RE: Transportation Comment Response Letter – SPA Submission (June 2026)
Proposed Commercial Development
12100 Creditview Road, Town of Caledon

LEA Consulting Ltd. (LEA) has been retained by Fieldgate Commercial to conduct a Transportation Comment Response Letter for the proposed commercial development located at 12100 Creditview Road (herein referred to as the “subject site”) in the Town of Caledon, in support of the Site Plan Approval (SPA) application.

1.1 TOWN OF CALEDON - PUBLIC WORKS & TRANSPORTATION DEPARTMENT COMMENTS – MAY 1, 2026

1.2 PEEL REGION – DEVELOPMENT TRANSPORTATION – MAY 13, 2026

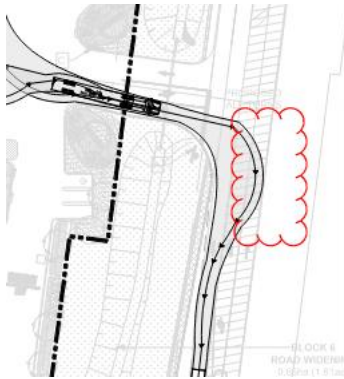
***Comment:** As previously noted, vehicles must enter and exit the proposed development without encroaching on oncoming traffic. An addendum letter with updated AUTOTURN attachments may be submitted instead of a full TIS update.*

LEA Response: Noted. Please refer to **Attachment 1** within this addendum letter for revised AUTOTURN.

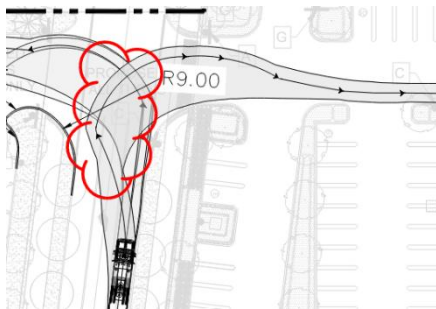
Comment 1: Creditview Road Full Moves Access: Eastbound right turns must not conflict with northbound through movements on Creditview Road. This area is a priority due to expected higher traffic volumes and imminent development.

Transportation Engineering requires the conflicts to be rectified. Increase the curb radii to 15 m, or blended with the right turn taper to provide the necessary pavement width as required. Alternatively, assess if a mountable curb with a gravel shoulder can offer additional space?

LEA Response: Addressed. A mountable curb has been incorporated to achieve a 15 m curb radius, which ensures that eastbound left-turn movements do not conflict with northbound through movements on Creditview Road. Please refer to **DWG 003** in **Attachment 1**.

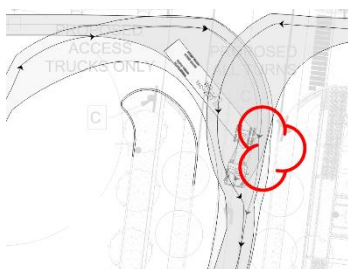
Comment 2: Street G Full Moves Access: Northbound right turns into Retail A area must not conflict with southbound through movements.

Similarly, northbound through movements should not conflict with westbound right turns out of retail C1/C2 loading bays.

Transportation Engineering requires this to be rectified either:

- Use a ~12 m curb radius for the northern accesses on Street G, southwestern and southeastern curbs (this functions in the middle access on Street G); or
- Due to lower speeds and volumes, mitigation measures which direct large trucks to enter via the middle access on Street G instead of the northern access could be supported.

LEA Response: Addressed. RB-62 (No Heavy Trucks) signage has been installed to direct trucks to use the middle access rather than the northern access, thereby eliminating the need to modify the northern access radii. It is important to note that northbound right turns do not conflict with southbound through traffic at the middle access. In addition, the curb geometry at the Retail C1/C2 access has been revised to eliminate conflicts between northbound through traffic and westbound right-turn movements exiting Retail C1/C2. Please refer to **DWG 004** in **Attachment 1**.

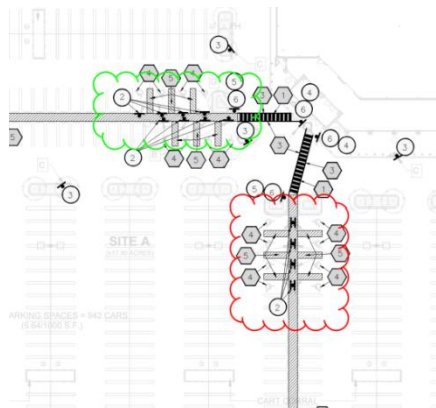
Comment 3: *Revise the internal Pavement Markings Signage Plan and Site Plan to communicate that signs must be installed at the edges of walkways according to typical standards (green), not in the middle of walkways (red). This will ensure clear walkways at pinch points, thus ensuring compliance with AODA requirements.*

LEA Response: Noted. Pavement Marking Signage and Site Plan have been revised to indicate that signs must be installed at the edges of walkways.

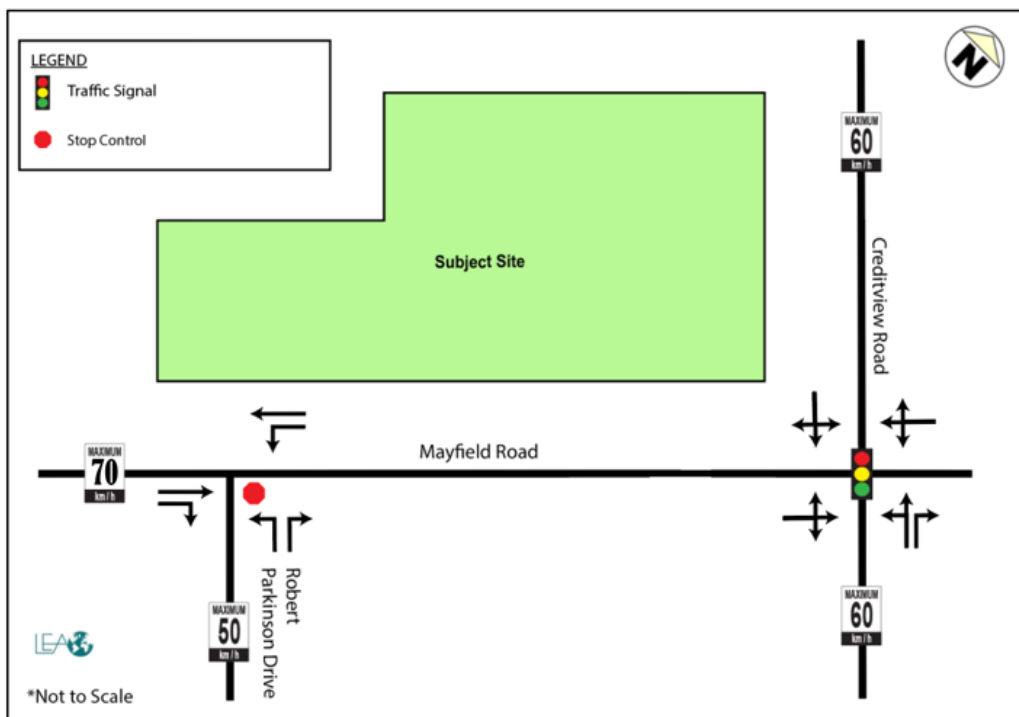
Comment: The circled parking spaces are likely not feasible for entry or exit. Since the required parking supply is met, alternatives such as hatching a parking space or relocating the waste bins can be addressed through redlines.

LEA Response: Addressed. The parking spaces shown in the figure above have been revised and are now illustrated as hatched. Please refer to **DWG 013** in **Attachment 1**.
